Service Bulletin

Bulletin No.: 17-NA-040

Subject: Brake Squeal or Squeak Noise Intermittently on Initial Brake Applies

3326987

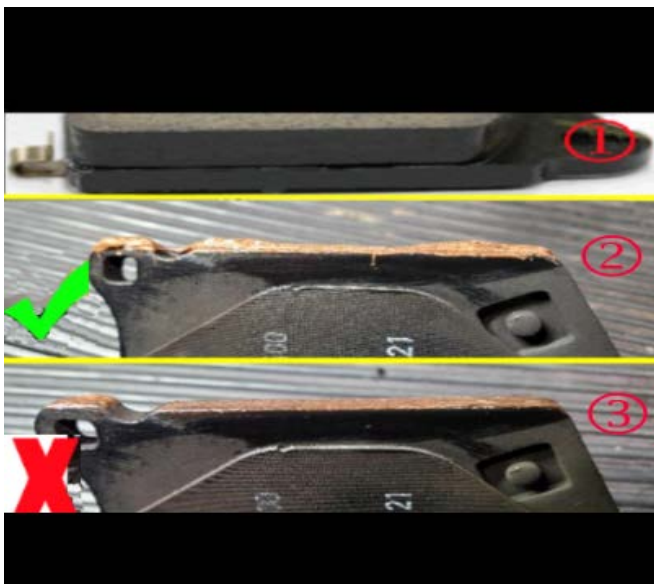
Apply a coat of copper paste to completely cover the pad backing plate abutments on each end. The paste should not extend onto the friction material. Follow the instructions listed below.

1. Remove the front disc brake pads. Refer to *Front Disc Brake Pads Replacement* in SI.
2. Using acrysol Kent Industries Part# P2005 or equivalent, wipe clean both ends of the abutment area on the front pads and calipers.
3. Apply approximately 0.10 g (0.0035 oz) of copper paste to each end of the disc brake pad abutments that contact the brake caliper bracket.

5926095

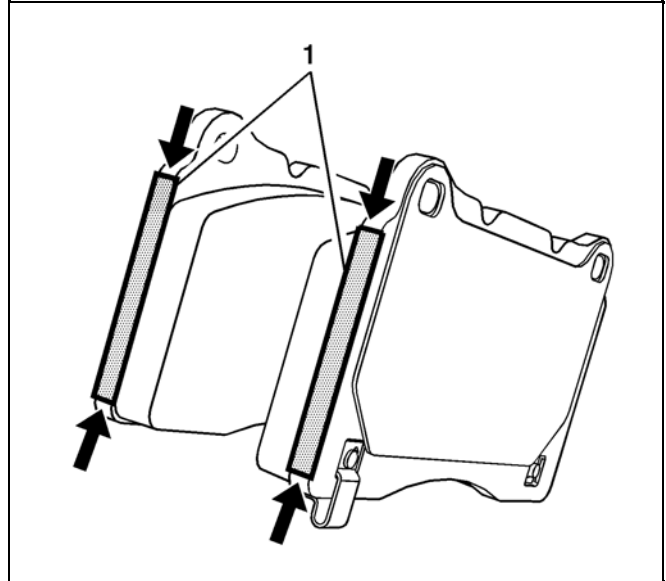
Note: Avoid a light apply of the paste as illustrated above.

5926095

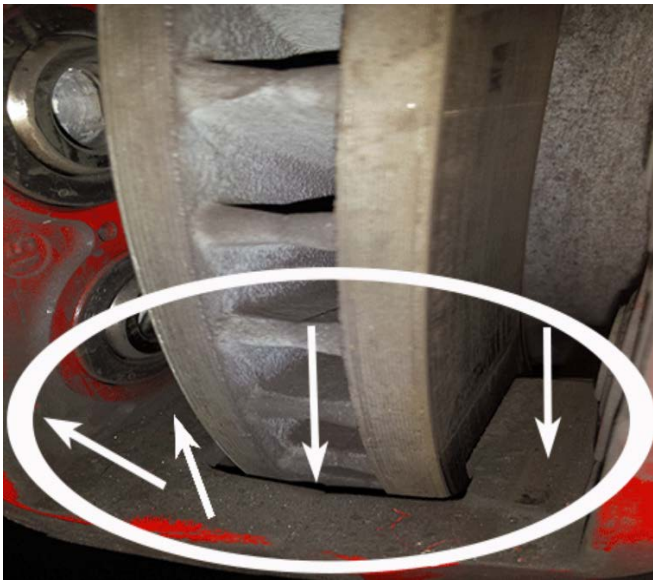
Note: Ensure that the ends of the brake pads have enough copper paste applied, if not, could result of the noise condition returning.

3. Using acrysol Kent Industries Part# P2005 or equivalent, wipe clean both ends of the abutment area on the front and rear pads and calipers.
4. Apply approximately 0.10 g (0.0035 oz) of copper paste to each end of the disc brake pad abutments that contact the brake caliper bracket.
